COVID-19 Walking and Cycling Emergency Response Measures: Melville Drive segregated cycleways

Response from Spokes – the Lothian Cycle Campaign, July
2020

This response considers the proposals shared by the Spaces for People Team on 17th July 2020

Fig 1: Additional red screeding & right turn suggested at Argyle PI junction

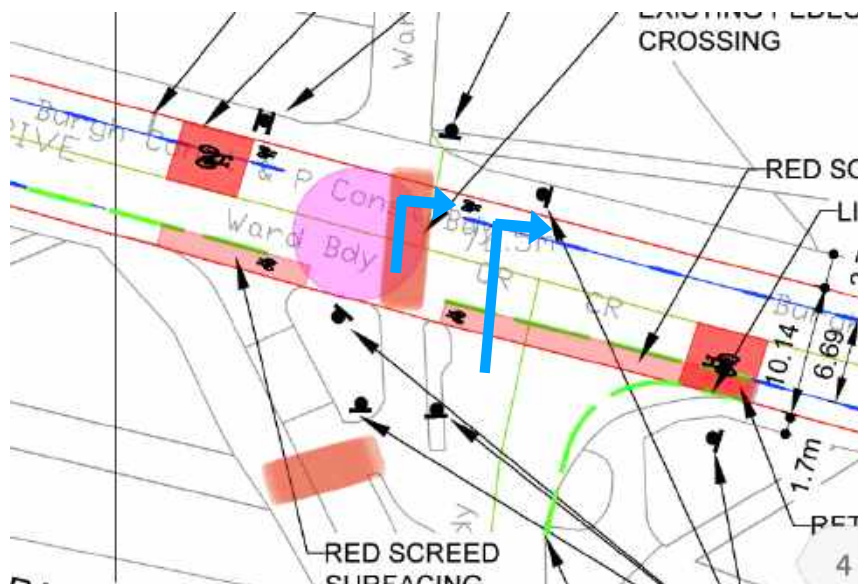
1. **Demarcation of cycle crossings at Junctions:** It is good to see that the red surface treatment is being added at the east-west crossings along Melville Drive. However it should also be applied north-south across Melville Drive at Argyle Place. Currently this lack of clear delineation often means vehicles block the Toucan crossing here. The new protected eastbound cones should be adjusted to allow a right turn from Argyle Place. Thus avoiding the desire to use the path along the southern edge of the pedestrian path of South Meadow Walk.

This surface treatment should also be applied to the crossing east-west from Argyle Park Terrace so drivers are made more aware the cycle route crosses here. Often drivers speed across if the lights are red if headed west, but this conflicts with cyclists headed south/west from Middle Meadow Walk on to Leamington Walk. See Fig 1 of the

proposed additional red screeding locations above.
